ADDENDUM NO. 8

(3/16/2021)

UCR BATCHELOR HALL RENEWAL PROJECT

PROJECT NO. 950464-950531

CONCEPTUAL PHASING
AXONS DIAGRAMS &
NARRATIVE

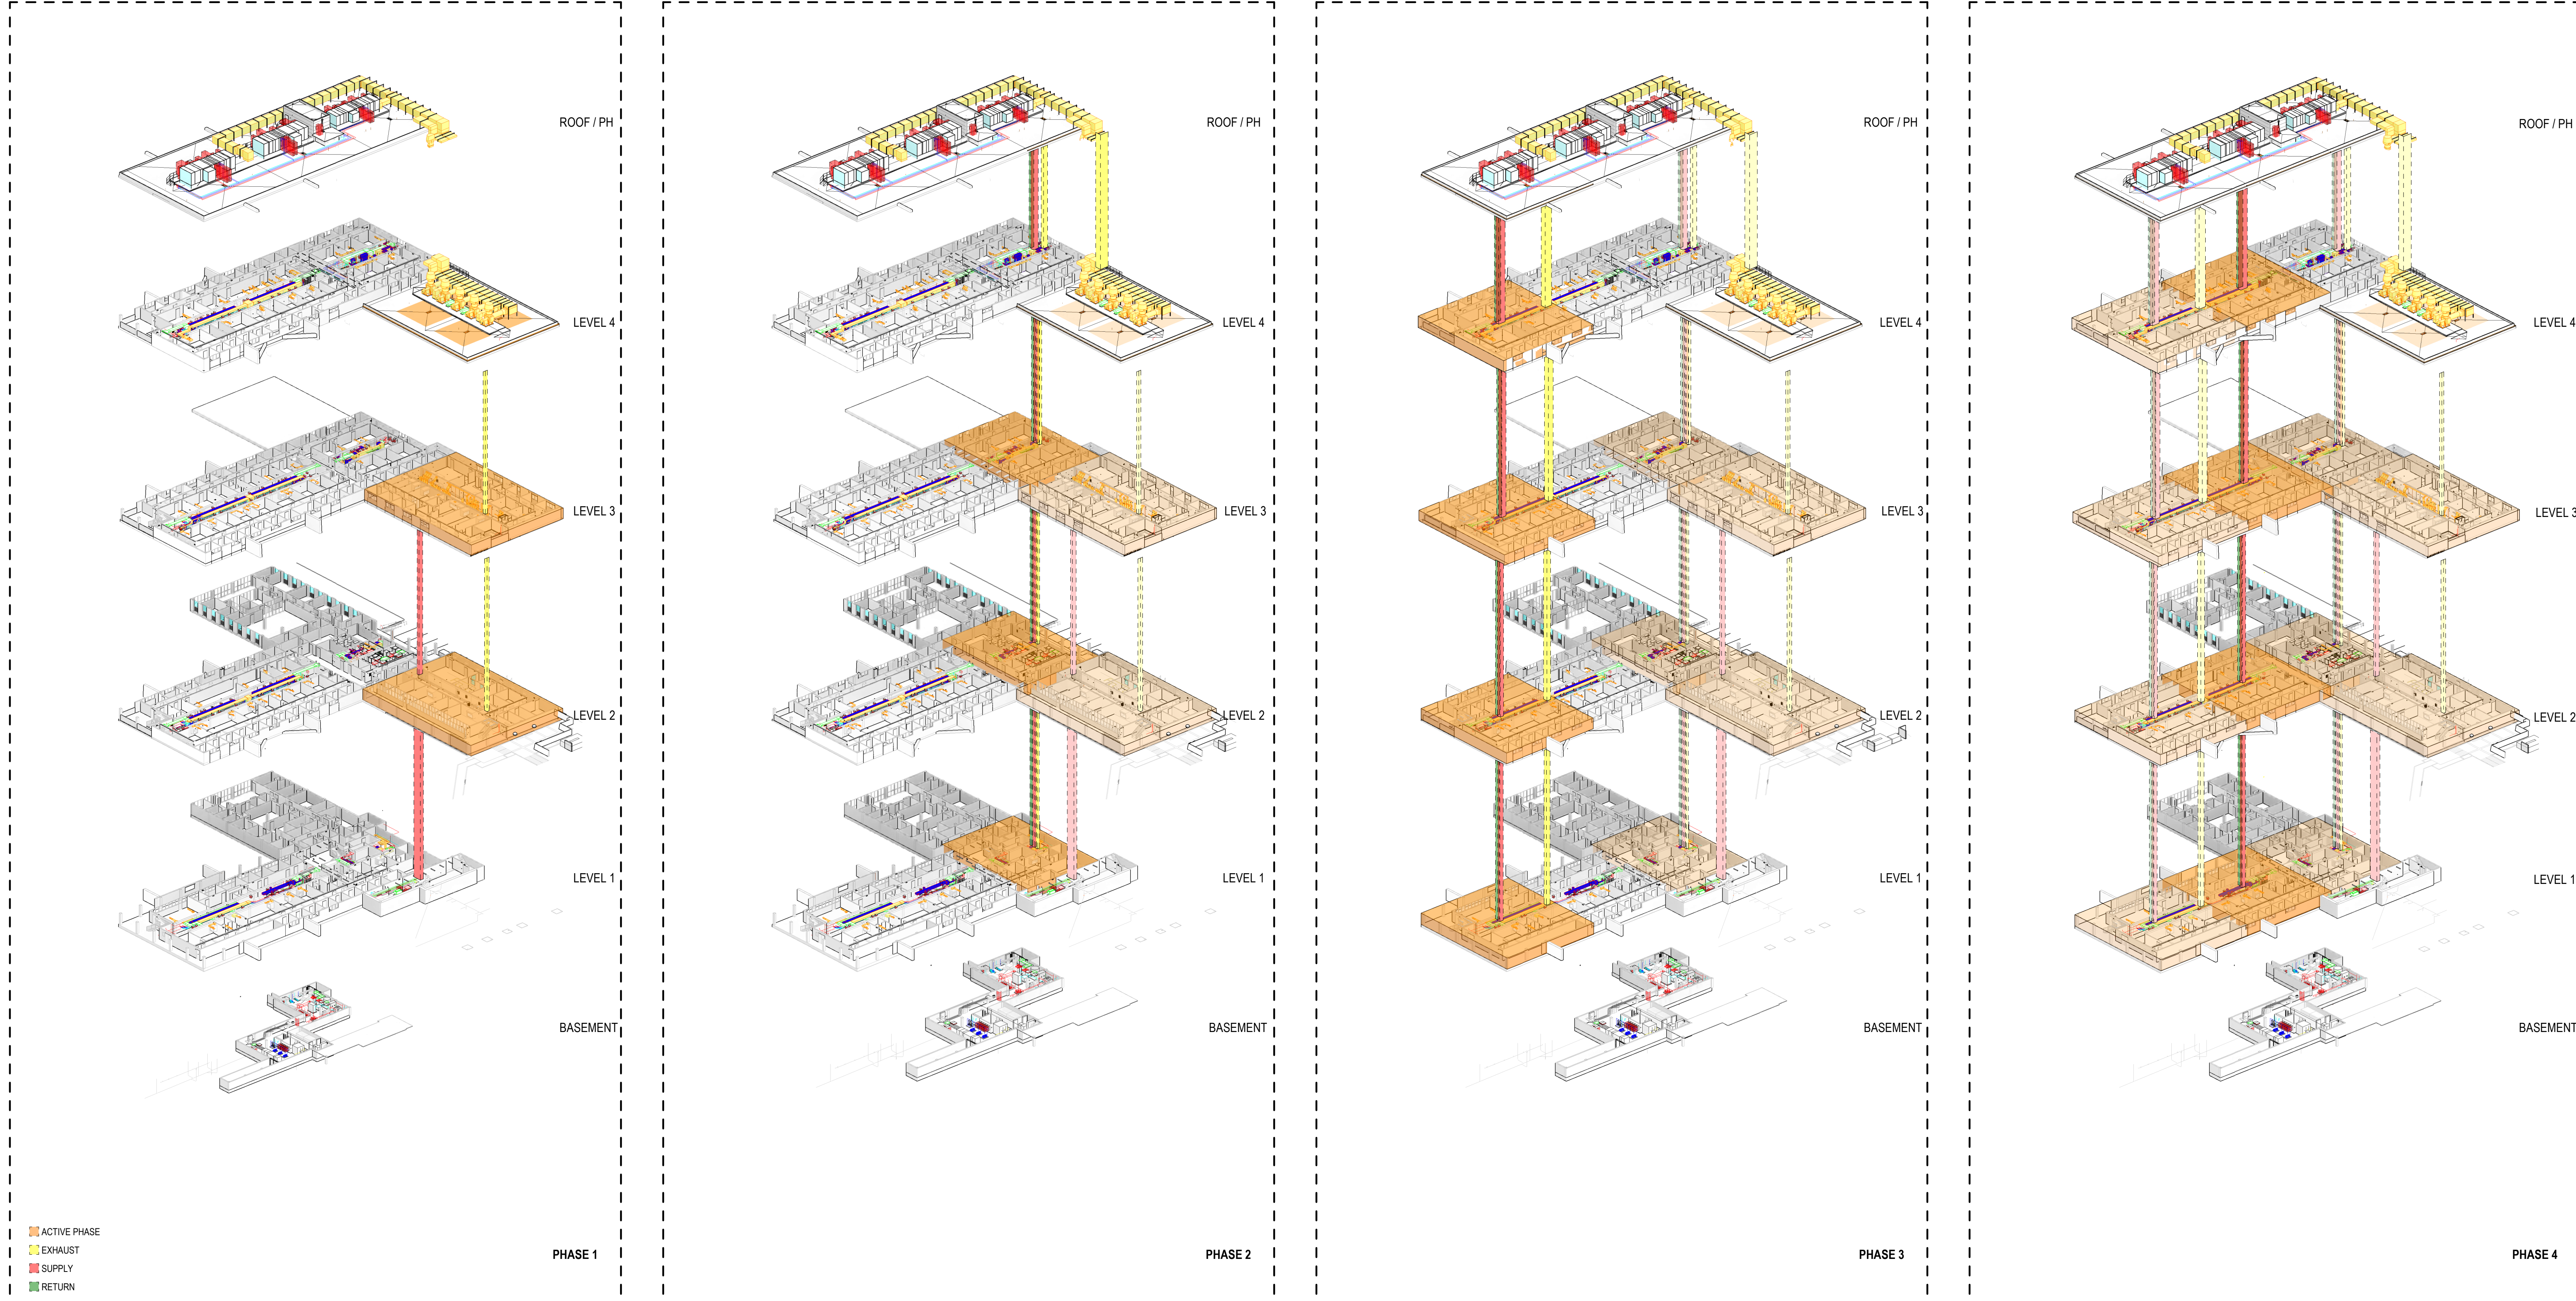
3. Delete drawing sheets G-201 and G-202 issued with the original bid documents and replace with the attached drawing sheets G-201 and G-202, Addendum No. 8 – 3/15/21.
4. Delete drawing sheet I-600 issued with the original bid documents and replace with the attached drawing sheet I-600, Addendum No. 8 – 3/15/21.
5. Delete Specification Section 14 22 00 issued with the original bid documents and replace with the attached Specification Section 14 22 00 ‘Modernization of Elevators’, Addendum No. 8 – 3/15/21.

THE FOLLOWING IS NOT INTENDED TO PROVIDE AN ALL-ENCOMPASSING PHASING PLAN BUT RATHER A GENERAL APPROACH THAT WILL NEED SIGNIFICANT DETAIL COORDINATED WITH THE ACTUAL FIELD CONDITIONS AND PHASING PLANS OF ALL DISCIPLINES.

ALL WORK MUST PROVIDE TEMPORARY UTILITIES FOR DURATIONS WHICH ARE DEEMED UNACCEPTABLE BY THE UNIVERSITY.

ARCHITECTURAL AND STRUCTURAL SCOPE TO BE COORDINATED WITH THE OWNER AND COMPLETED AS REQUIRED WITHIN EACH PHASE. FOR SCOPE THAT IS NOT PHASE DEPENDENT SUCH AS STAIR MODIFICATIONS, CONTRACTOR SHALL COORDINATE WITH CAMPUS FIRE MARSHAL AND OWNER FOR REQUIRED WORK.
